Title		
IRDY/TRDY Relationships		
Size	Document Number	Rev
B	Charles Krinke cfk@pacbell.net	B
Date:	Sunday, July 07, 2002	Sheet 1 of 1

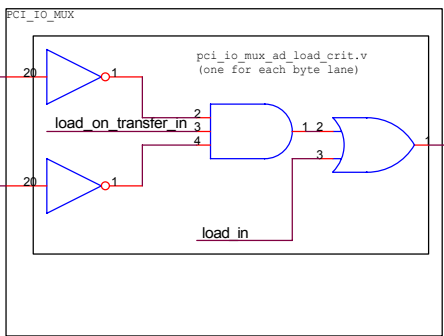
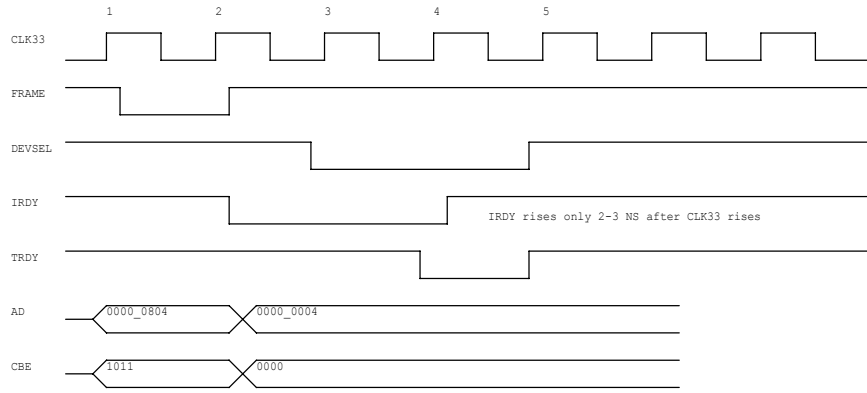
POTENTIAL PROBLEM #1:
 Since TRDY is assigned based on the IRDYnon-registered input, then pci_trdy_out, even if it is subsequently registered, may be too short to allow the rest of the logic to work correctly when IRDY & TRDY are crowding CLK from opposite directions.

WHERE I STARTED FROM:
 Basically, what happened is that I am unable to write to the command register in PCI space yet in order to set the memory enable bit, or change the BAR0. In searching why, I can see that load_to_conf_out does not assert. I am suspecting a timing problem because IRDY is asserted from the master initiating this configuration write and it de-asserts only 2NS after CLK33 rises.

POTENTIAL PROBLEM #3:
 Since IRDY is de-asserted a couple of NS after clk rises, the combinatorial logic in one of the connected blocks may not see IRDY before the clk signal internal to the FPGA as a result of PAR rises (this is a routing issue, but it is caused by the original logic PAR is attempting to route).

SUPPOSITION:
 Perhaps both IRDY & TRDY should only be used as registered variables so they exist for one complete clock cycle for the combinatorial logic. Unfortunately, I am not familiar enough yet with the logic, nor am I sure I am right in the first place to make these changes.

POTENTIAL PROBLEM #2:
 Since IRDY & TRDY are used in combinatorial logic sometimes, the fact that they are both asserted for only a few NS may cause the logic to work incorrectly.
